ADDENDUM NO. CC-1

TELEGRAPH DISTRICT
401 BUILDING RENOVATION
LINCOLN, NEBRASKA
DLR GROUP PROJECT NO. 10-16202-00

February 26, 2016

Attachment No. A3.2-1
to Addendum NO. 1
Dated: 3/11/16

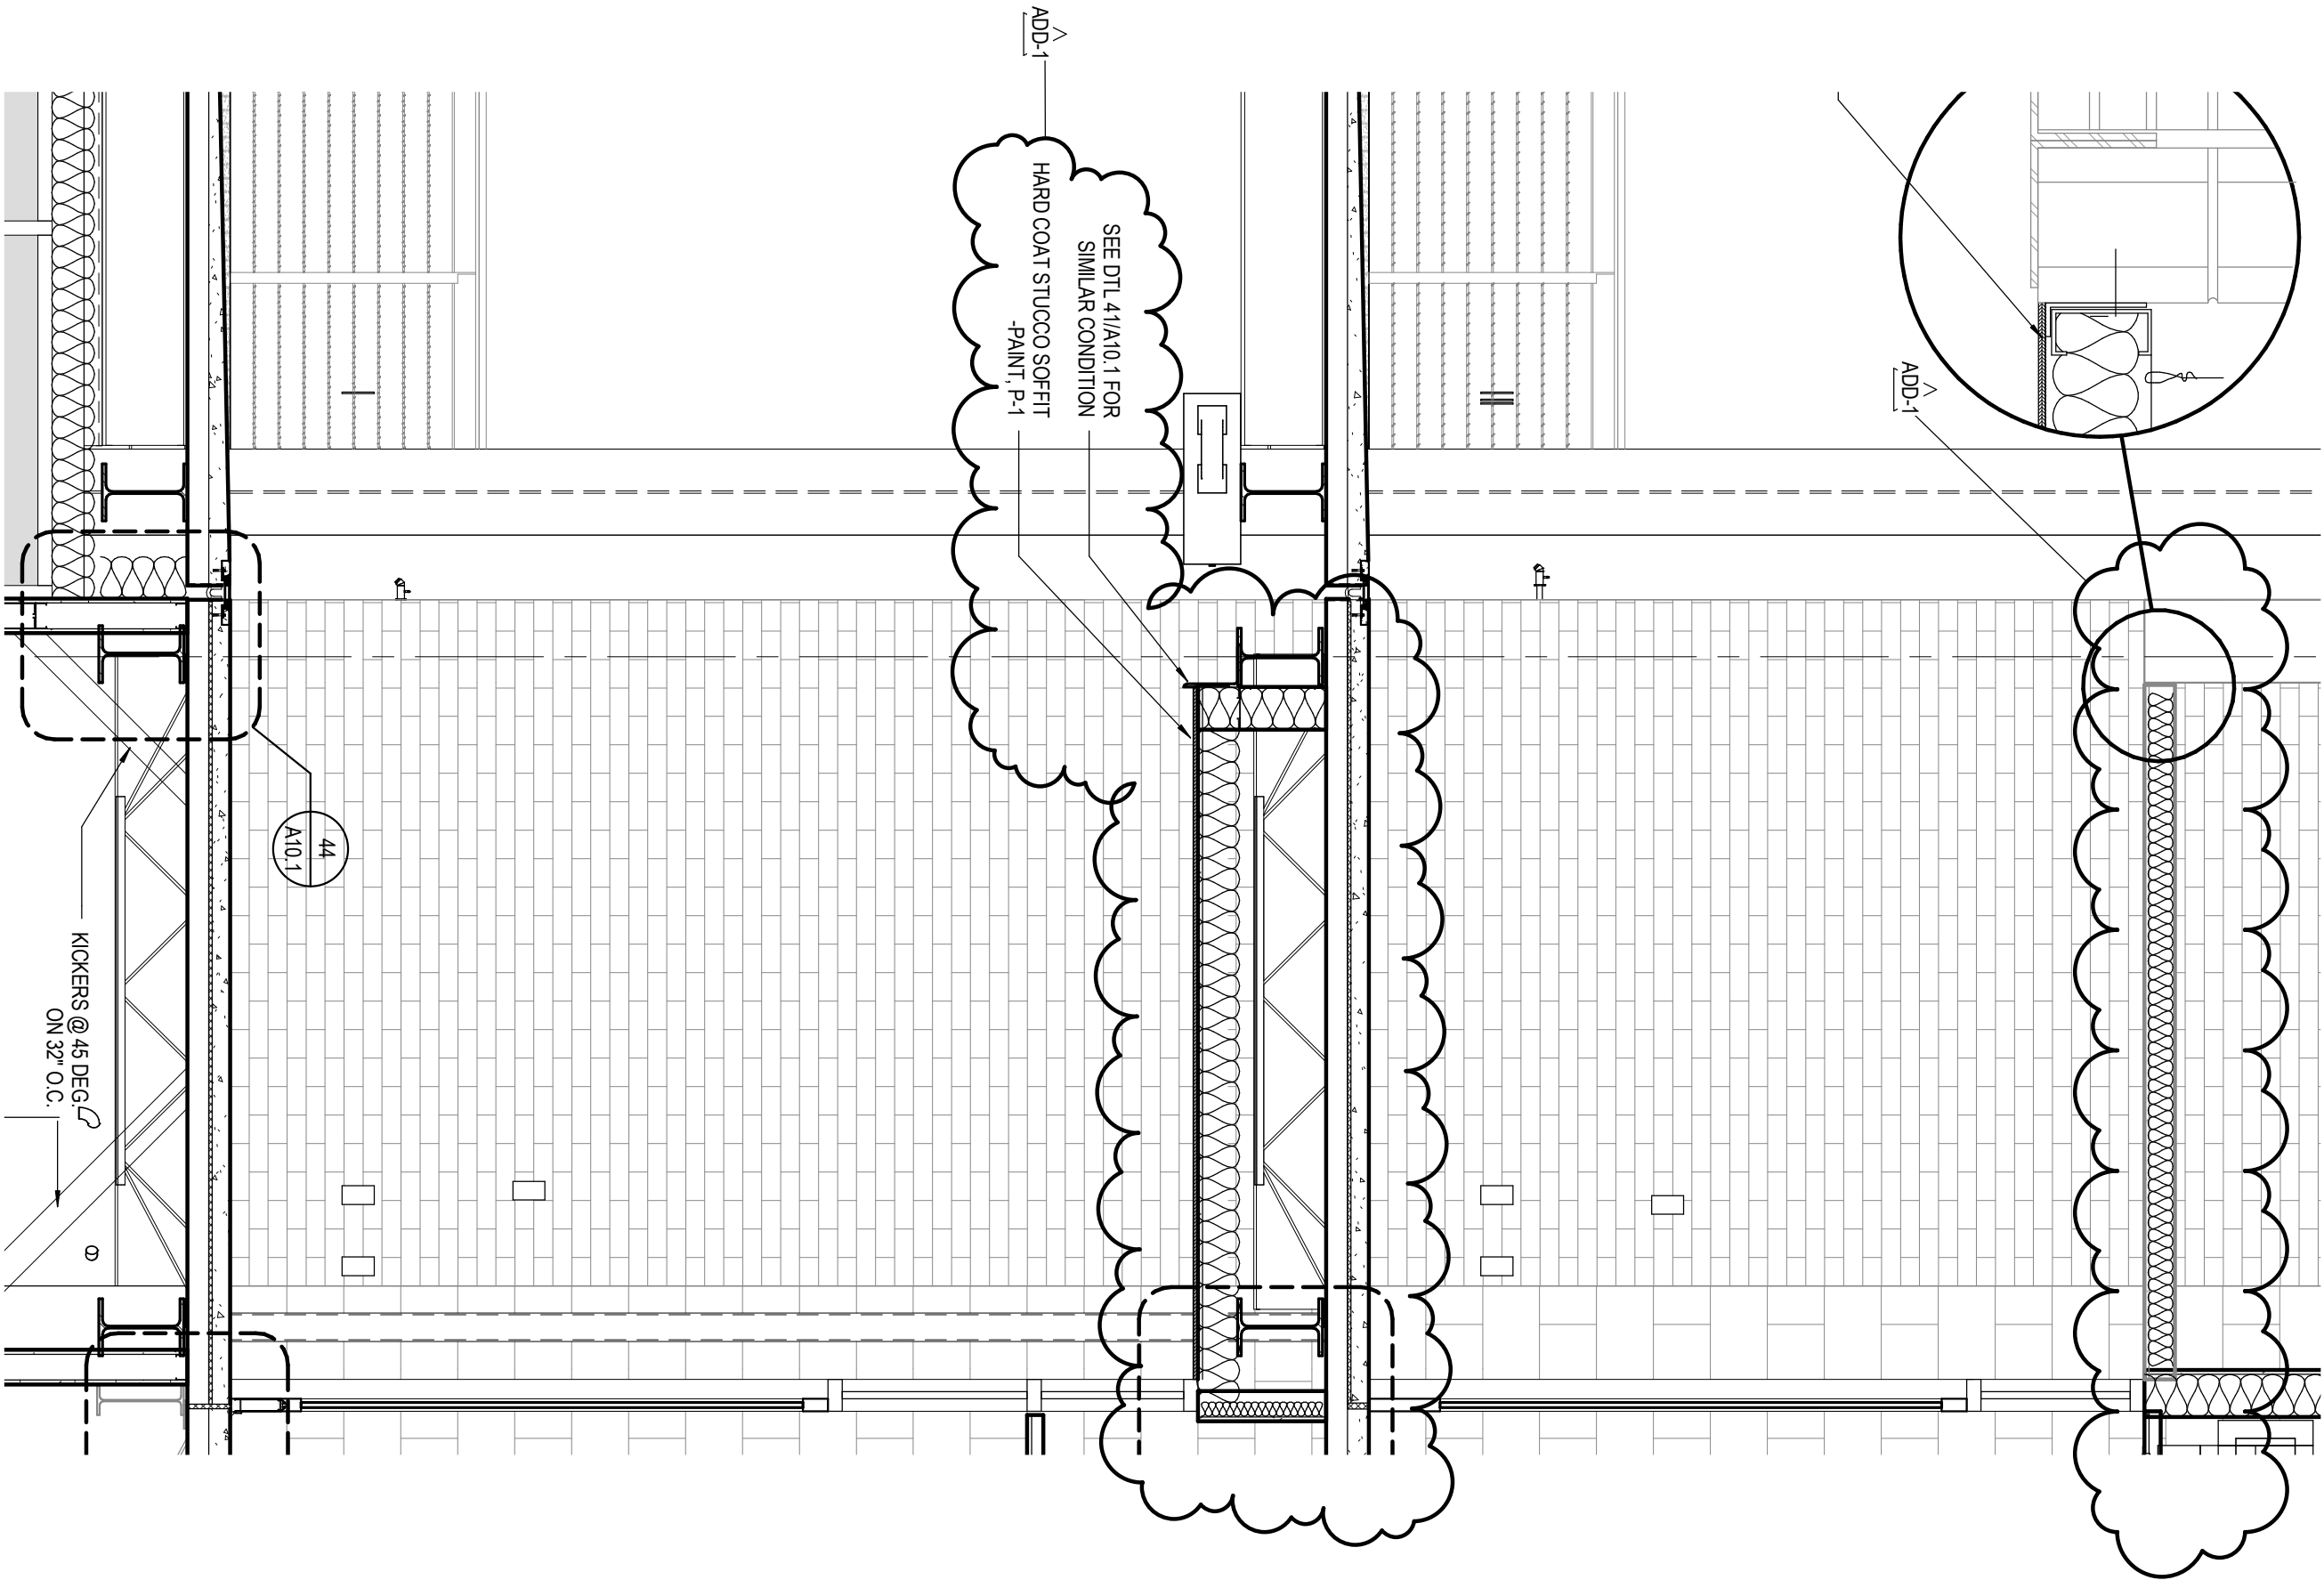
ITEM NO. 3 DRAWING A3.2 REFLECTED CEILING PLAN, SECOND LEVEL

- A. Modify drawing as shown on Attachment A3.2-1

ITEM NO. 4 DRAWING A3.3 REFLECTED CEILING PLAN, THIRD LEVEL

- A. Modify drawing as shown on Attachment A3.3-1

PLUMBING DEMOLITION PLAN, BASEMENT LEVEL

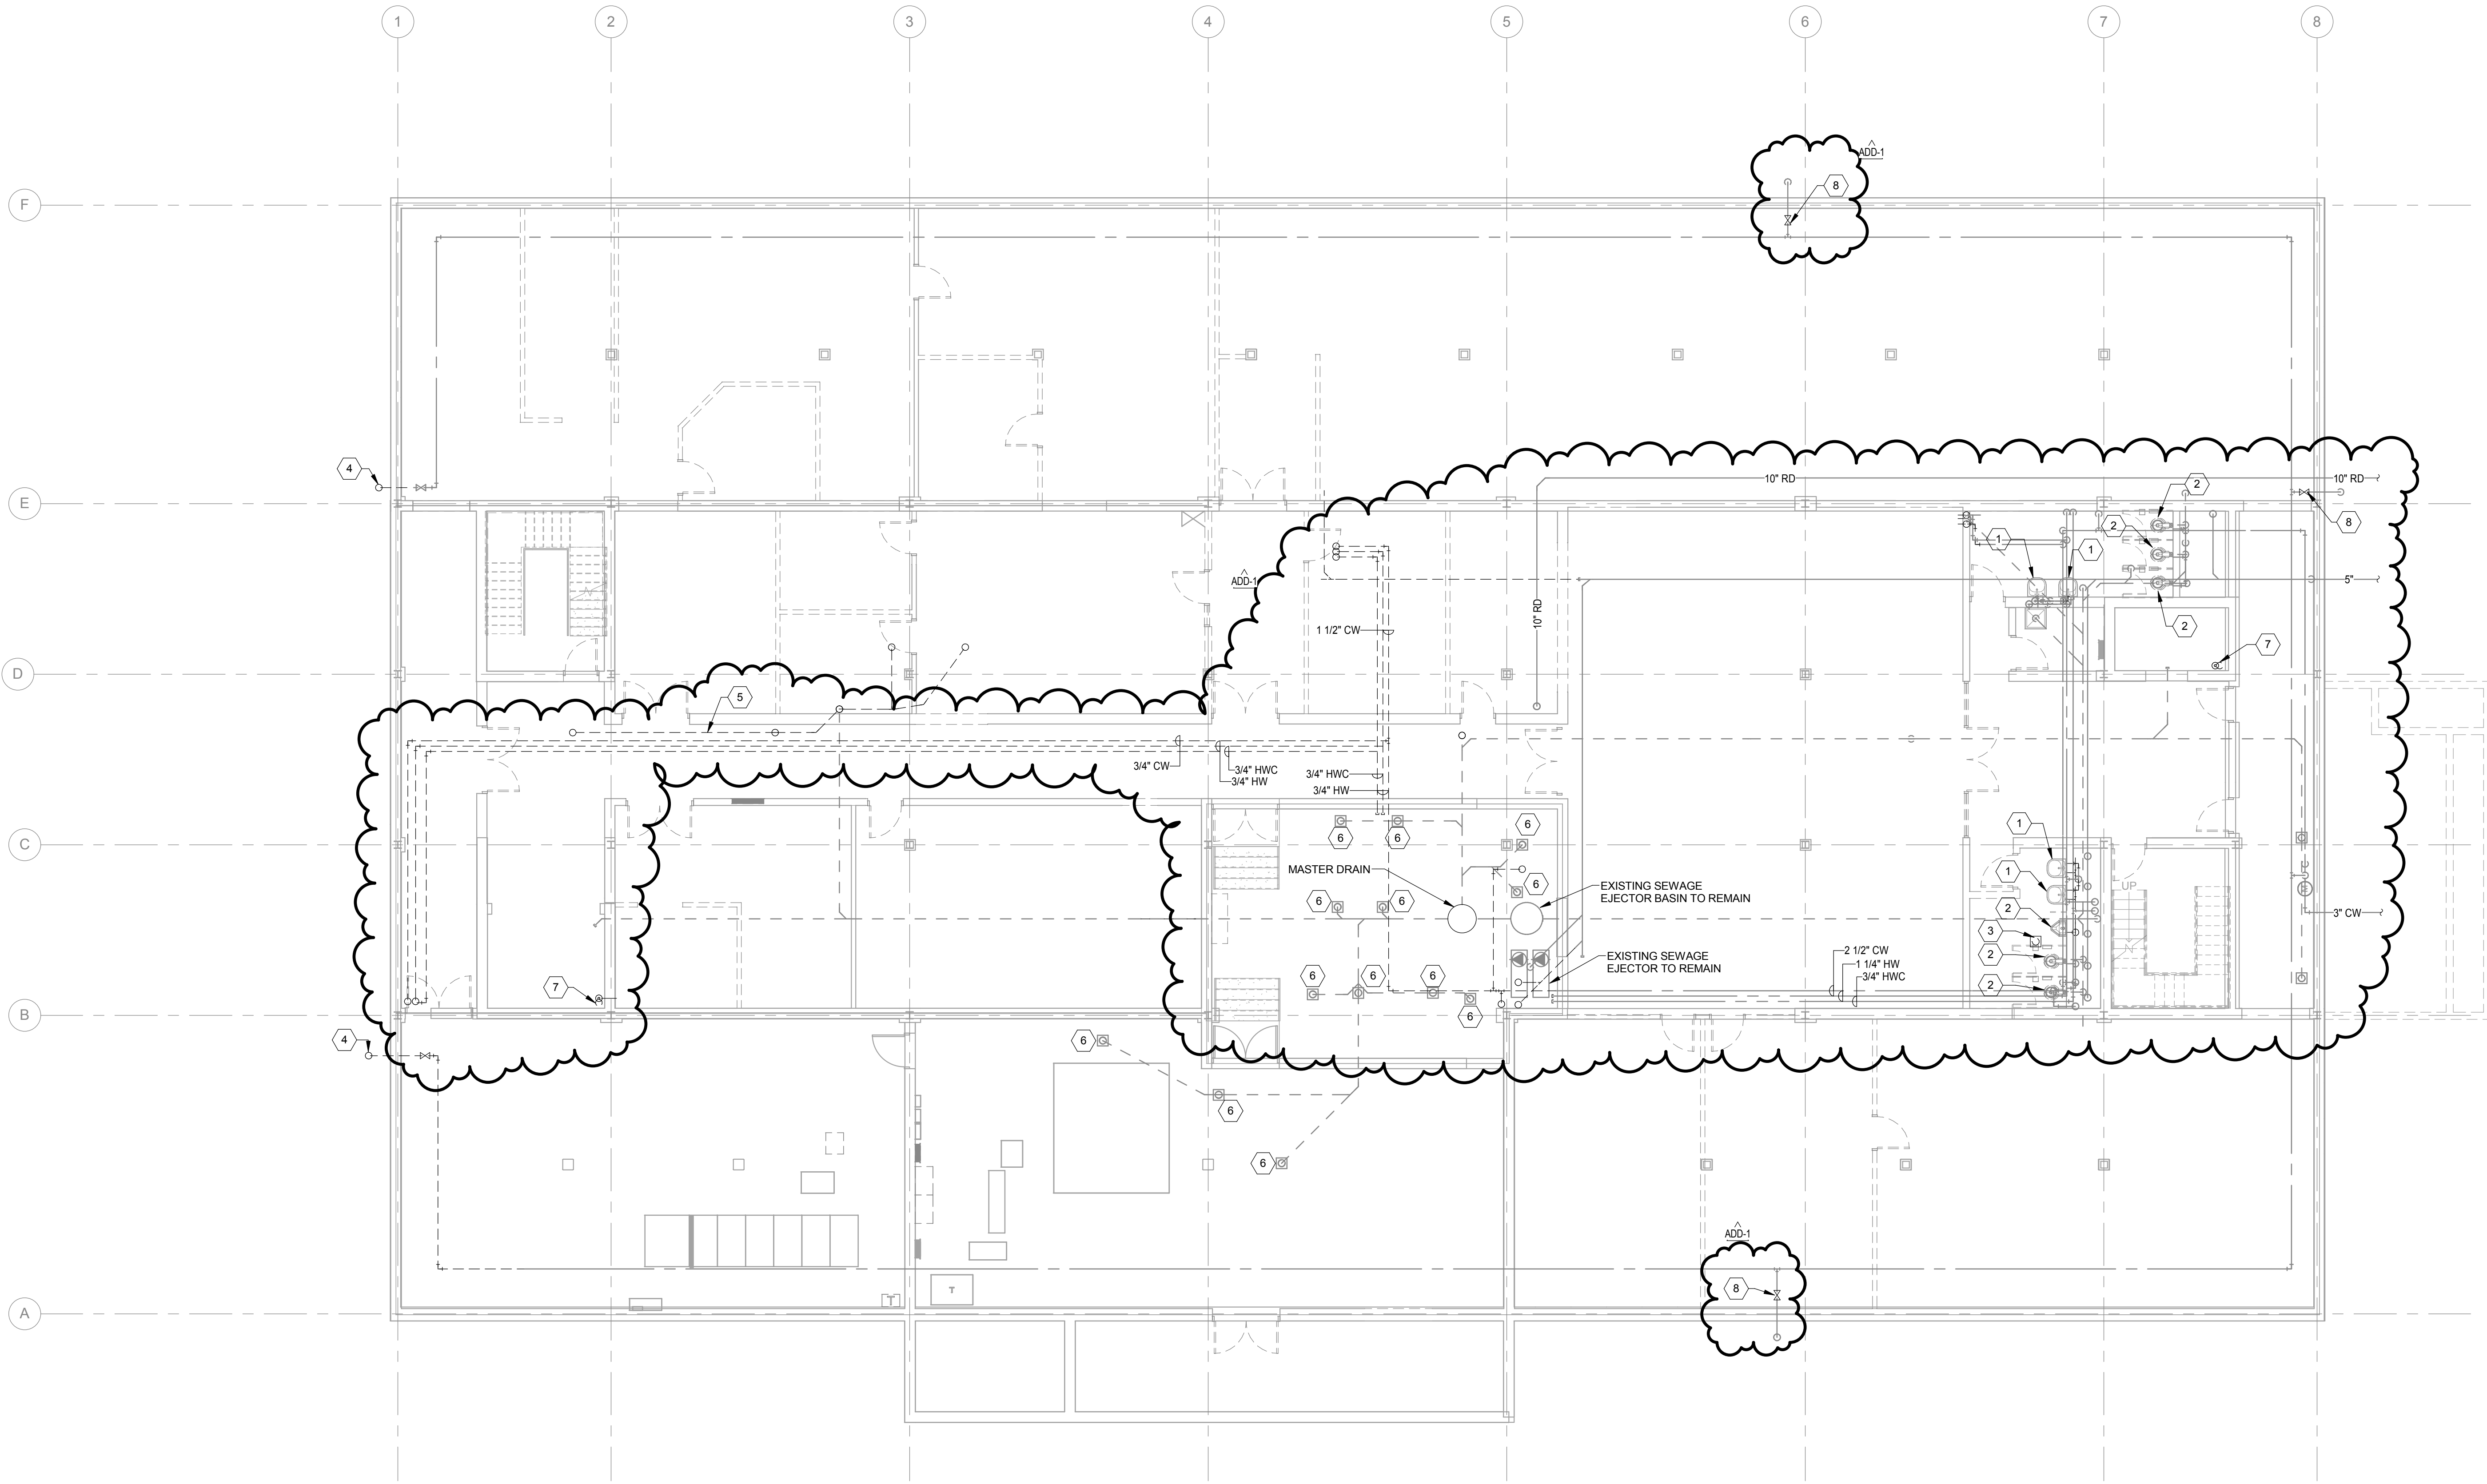
ITEM NO. 6 DRAWING PD1.0 PLUMBING DEMOLITION PLAN, BASEMENT LEVEL

- A. Revise the drawing as shown in the attachment PD1.0 for modifications to the plumbing demolition plan.
B. Replace the existing valves to ground hydrants as shown.
